Rezoning Application: PD 25-1382
Zoning Hearing Master Date: February 23, 2026
BOCC Land Use Meeting Date: April 07, 2026

AGENCY REVIEW COMMENT SHEET

DEVELOPMENT REVIEW STAFF REPORT

**GENERAL
SITE PLAN
FOR
CERTIFICATION**

8.0 PROPOSED SITE PLAN (FULL)

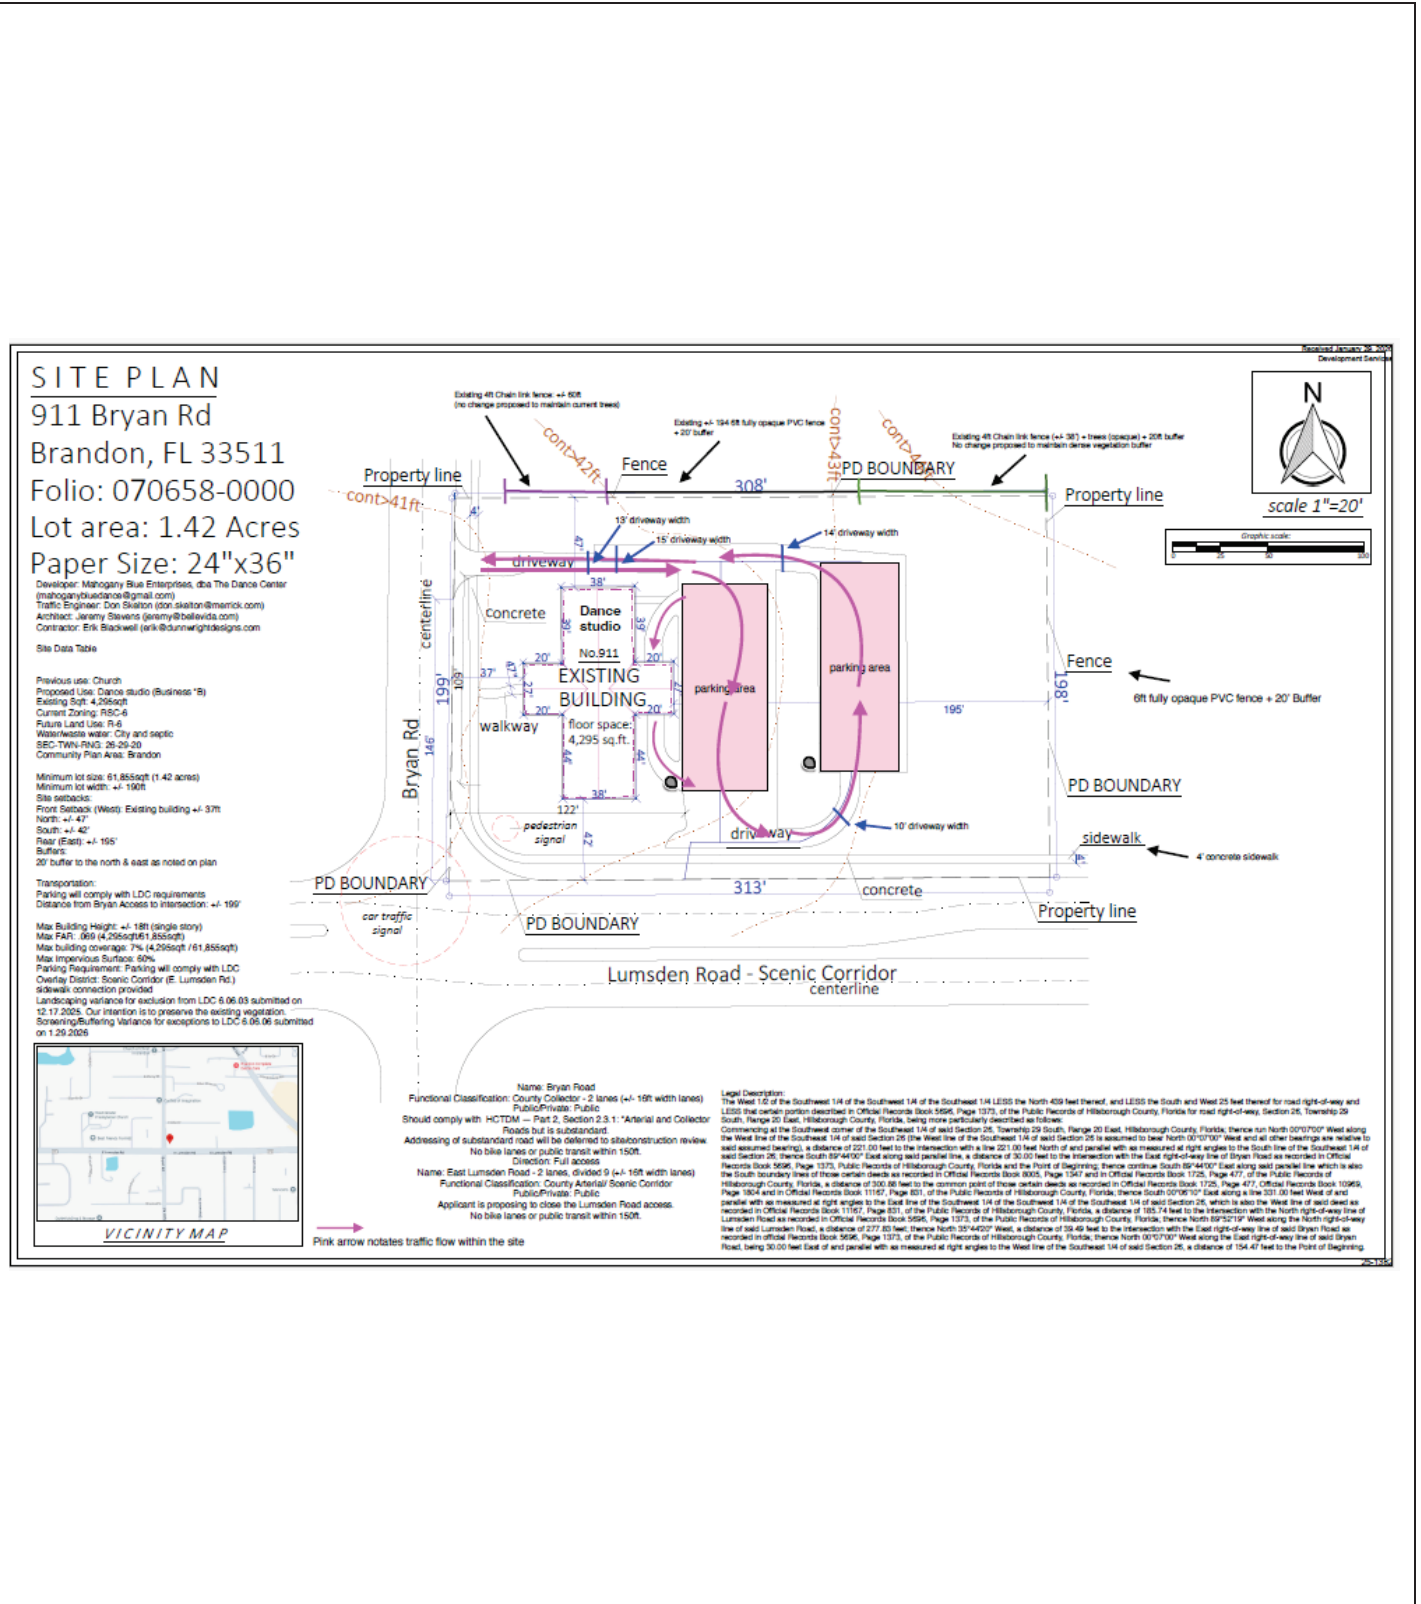
Prior to PD Site Plan certification, the developer shall revise the PD site plan to:

Change the Proposed Use under the Site Data Table to reflect the LDC Article II terminology for the proposed use (Recreational Uses, General Indoor).

- 3.1 Along the northern boundary, a minimum 20-foot-wide buffer shall be provided. Existing vegetation shall be preserved, unless otherwise directed to be removed by Natural Resources. A 4-foot-high chain-link fence shall be provided along the western and eastern portions of the northern boundary, and a 194-foot-long 6-foot high fully opaque PVC fence shall be provided along the central portion of the northern boundary, as depicted on the site plan.

- 3.2 Along the eastern boundary, a minimum 20-foot-wide buffer shall be provided with the preservation of existing vegetation (unless otherwise directed to be removed by Natural Resources), and a 6-foot-high fully opaque PVC fence shall be installed, as shown on the site plan.

4. The development shall be served by and limited to one (1) full-access connection to Bryan Road as shown on the PD Site Plan. Such access may be restricted in the future due to safety or operational considerations. The developer shall close the existing access to E Lumsden Road and restore curbing, sod, and sidewalks, as necessary.

SITE PLAN

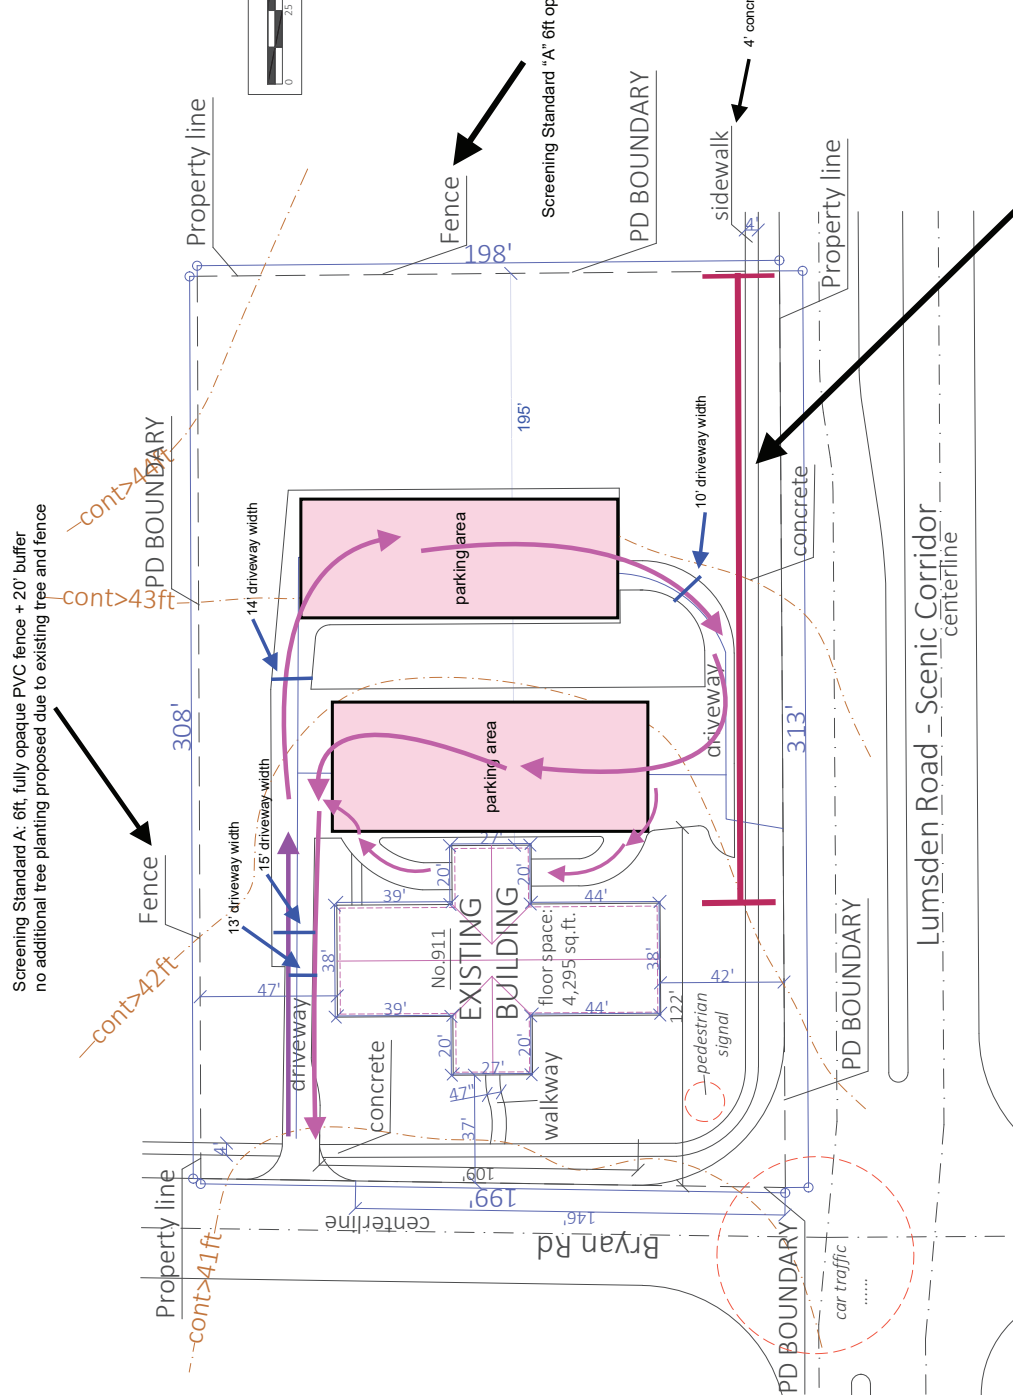
- Section 6.04.07 to provide access on Bryan Road to proposed development.
 - The proposed driveway does not meet the Hillsborough County minimum spacing requirements per LDC Section 6.04.07. Minimum connection spacing for a Class 6 roadway is 245 feet.

The proposed driveway on Bryan Road is needed to provide reasonable access to the proposed site. The Hillsborough County LDC Section 6.04.07 states that the minimum driveway spacing is 245 feet. **Table 1** contains access points within the minimum spacing distance from the proposed site’s driveway. The subject parcel has approximately 150 feet of available frontage along Bryan Road and due to the low number of projected trips, qualifies for only one driveway. Lumsden Road intersects Bryan Road to the south, making it difficult to relocate the driveway further south without impacting traffic operations at the intersection. Based on the dimensions of the subject parcel and the minimum driveway spacing requirements, reasonable access cannot be provided to the parcel without an administrative variance.

SITE PLAN

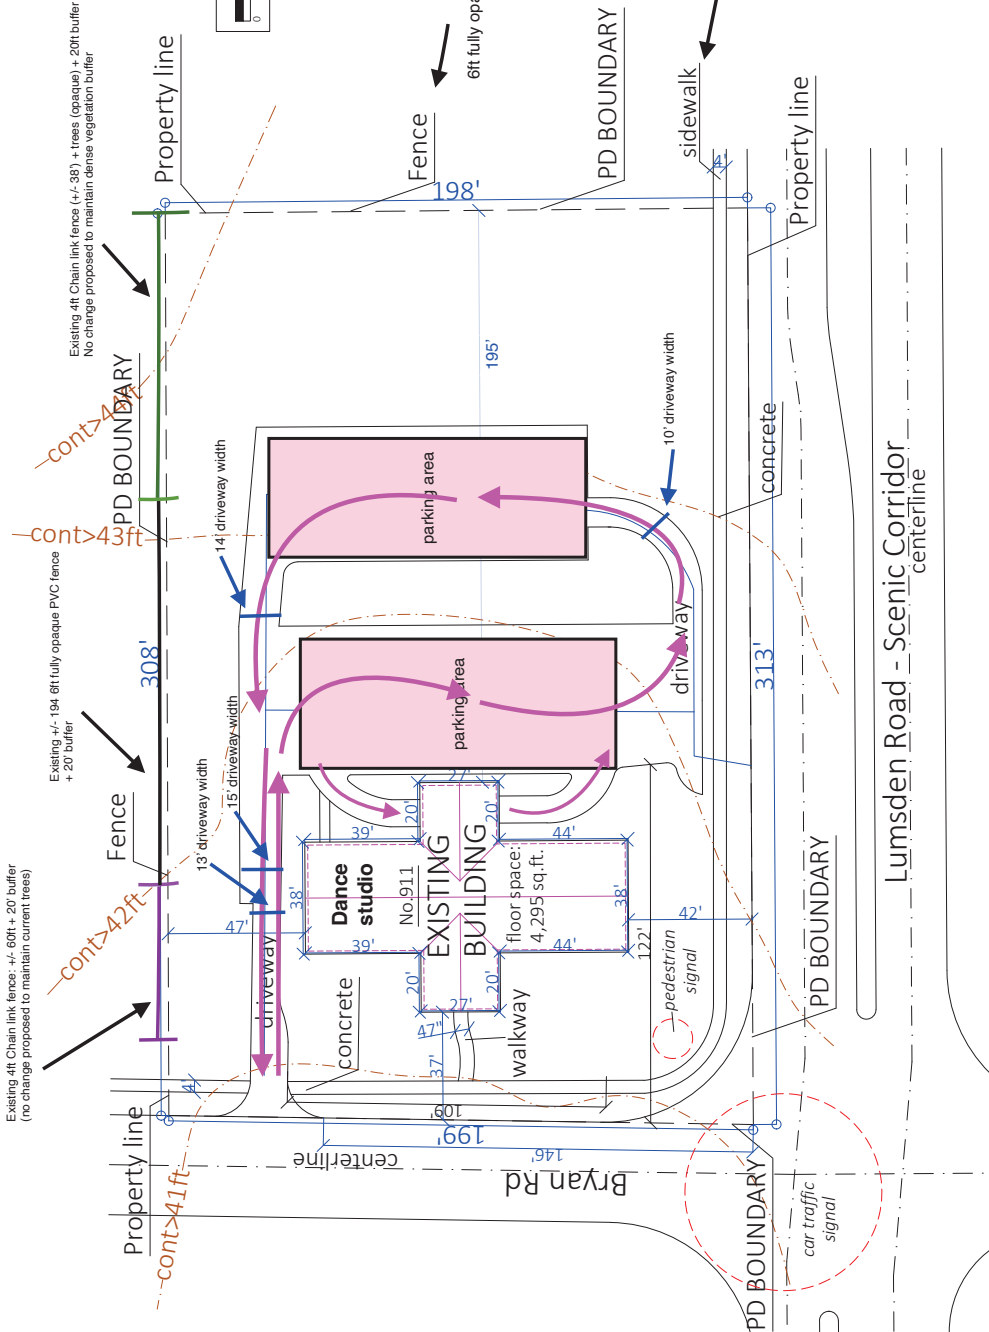
- The development shall be served by and limited to one (1) full-access connection to Bryan Road as shown on the PD Site Plan. Such access may be restricted in the future due to safety or operational considerations. The developer shall close the existing access to E Lumsden Road and restore curbing, sod, and sidewalks, as necessary.

- Prior to PD Site Plan certification, the developer shall revise the PD site plan to:
 - Change the Proposed Use under the Site Data Table to reflect the LDC Article II terminology for the proposed use (Recreational Uses, General Indoor).

Previous use:	Church
Proposed Use:	Recreational Uses, General Indoor
Existing Sqft:	4,295sqft
Current Zoning:	RSC-6
Future Land Use:	R-6
Water/waste water:	City and septic
SEC-TWN-RNG:	26-29-20
Community Plan Area:	Brandon
Minimum lot size:	61,855sqft (1.42 acres)
Minimum lot width:	+/- 190ft
Site setbacks:	
Front Seaback (West):	Existing building +/- 37ft
North:	+/- 47'
South:	+/- 42'
Rear (East):	+/- 195'
Buffers:	
	20' buffer to the north & east as noted on plan
